This is to certify that I have surveyed the property known as: LOT 1 "ALPHA ACRES" (12075 ROUTE 99) AS RECORDED AMONG THE LAND RECORDS OF HOWARD COUNTY, MD. AS PLAT # 6328

Monday, February 27, 2006

RE: Tank to a Foundation Variance Request

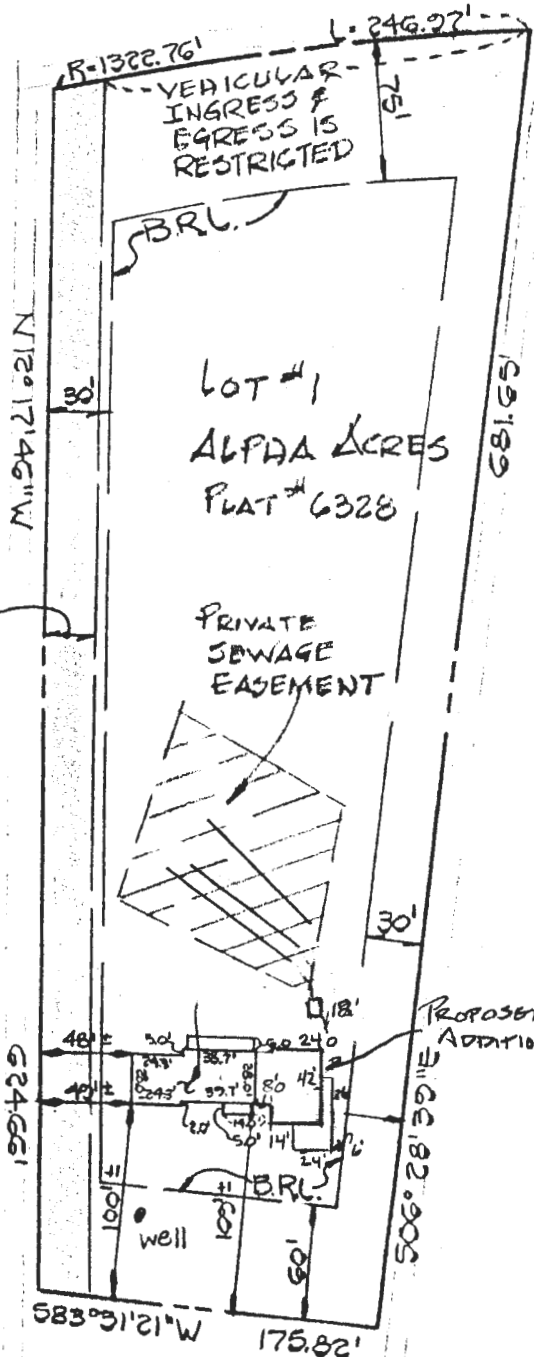
We are in the process of building an addition onto our house at 12075 Old Frederick Rd. As we considered the best location to meet our needs and what would blend well with the existing dwelling, we arrived at the design that was submitted under permit #B00157864. However in review of these plans we were informed by the Health Department that there was one issue with the addition not meeting the required set back from the septic tank. The addition would be 15' from septic tank instead of the required 20'.

1. We feel that moving the addition back 5' would not tie to the existing dwelling as well as the design that was submitted.
2. The top of the existing septic tank elevation is 19" below the elevation of the proposed additions basement floor. Therefore alleviating any possibility of ground water leaching into basement.
3. Having to move the septic tank 5' would add extra expense to the project.

The Howard County Department of Health has received a variance requesting the required twenty foot setback to a foundation for a septic tank at the above referenced property be waived to fifteen feet. This Department will grant your approval for the variance at the property as long as the new floor elevation is higher than the existing grade above the septic tank.
